Subject: **GEOTECHNICAL INVESTIGATION**
Proposed Construction of
New Residence Buildings and Accessory Structure
385 Fairview Road, Ojai, CA 93024

County of Ventura
Planning Commission Hearing
Case No. PL18-0052
Exhibit 4 (MND), Attachment 10 - Feffer Geotechnical Report, dated July 7, 2014,
Addendum, dated October 17, 2017 and Responses to Application
Incompleteness determination, dated October 29, 2018

Subject: **RESPONSE TO VENTURA COUNTY**
 Determination of Application Incompleteness
 Major Modification to Conditional Use Permit (CUP) No. 3048
 Case No. PL18-0052, Camp Ramah

Reference: **GEOTECHNICAL INVESTIGATION**
 Proposed Construction of New Residence Buildings and Accessory Structure
 385 Fairview Road, Ojai, CA 93024
 By Feffer Geological Consulting, dated July 7, 2014

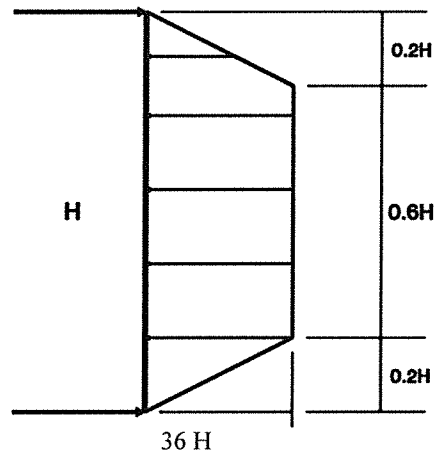
Please discuss why a City of Los Angeles standard has relevance on a project in the County of Ventura (Feffer Report dated October 16, 2017, page 4). Also, the seismic force is an added force to the static force. Thus, the last sentence under retaining walls discussion on page 4 should be explained and revised as necessary.

Restrained walls should be designed for an at-rest earth pressure of 60 pcf. The increase in lateral pressure due to earthquake loading can be estimated using the Mononobe-Okabe theory, as described by Seed and Whitman (1970). The estimated dynamic lateral force increase (due to seismic loading) for either restrained or unrestrained walls may be taken as $10H$ pounds per square foot of wall. The centroid of the dynamic lateral force increase should be applied at a distance of $0.6 \times H$ above the base of the wall. The distribution of the resultant dynamic lateral force can be assumed to be an invert triangle (base of the triangle at top of the wall).

To estimate the total dynamic lateral force, the dynamic lateral force increase should be added to the static earth pressure force computed using an active (not at-rest) lateral earth pressure of 43 pcf, equivalent fluid weight.

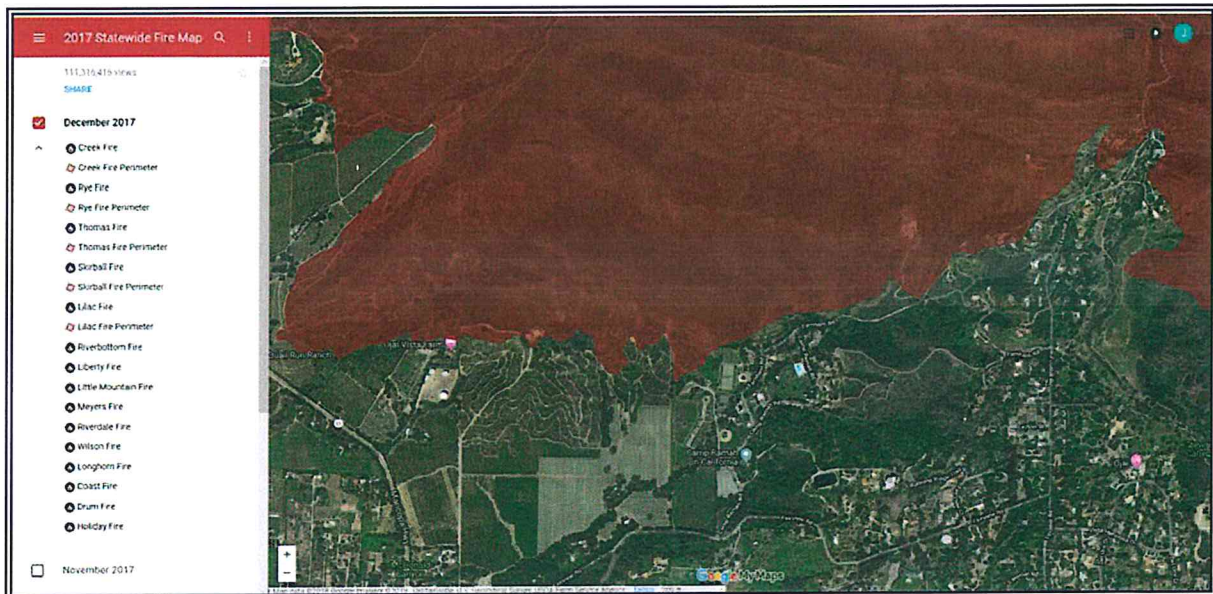
Please address the hazard of debris flow with respect to the location of the proposed Machan village. The Feffer Report was prepared in 2017, prior to the occurrence of the Thomas Fire that affected the Camp Ramah site. Provide an updated report that addresses the debris flow impact and provide mitigation as necessary.

Updated plans show the structures will be constructed into the base of the ascending slope. A Map showing the extent of the Thomas Fire Burn Area by Cal Fire and shown on <http://www.fire.ca.gov/general/firemaps> is shown below.

View of the slope above the proposed structures

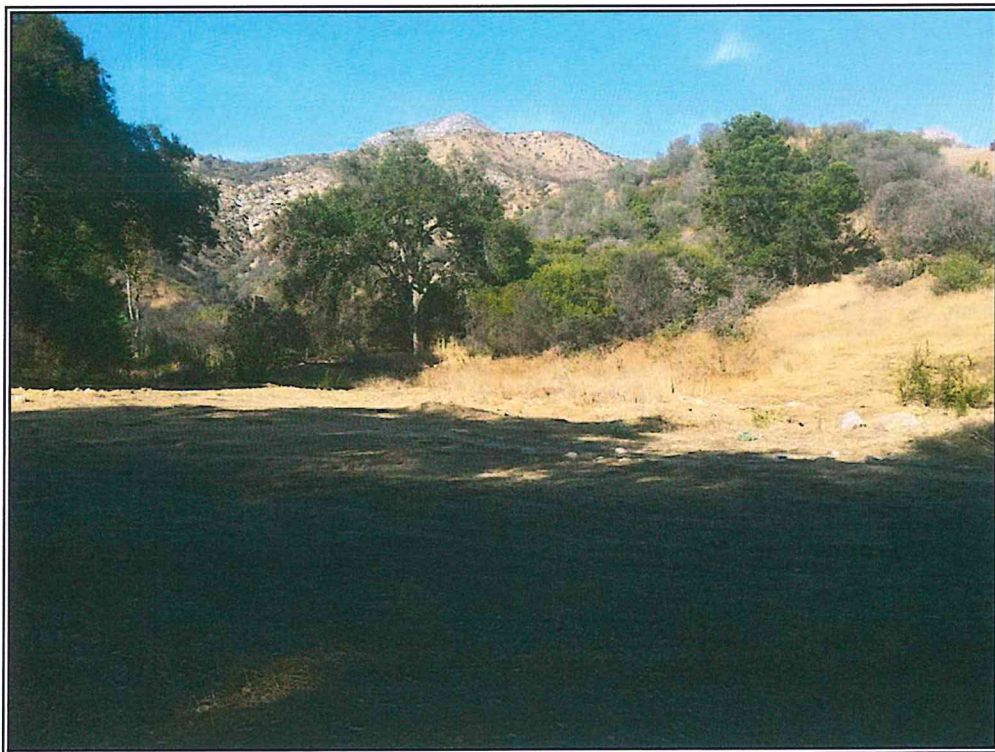
- 9. Please address the hazard of debris flow with respect to the location of the proposed Machon village. The Feffer Report was prepared in 2017, prior to the occurrence of the Thomas Fire that affected the Camp Ramah site. Provide an updated report that addresses the debris flow impact and provide mitigation as necessary.

We visited the subject site and took photos of the area above the new proposed buildings. These photos are included at the back of this response. The slope above the proposed campground shows no evidence of recent burn, is in good condition, and covered with chaparral.
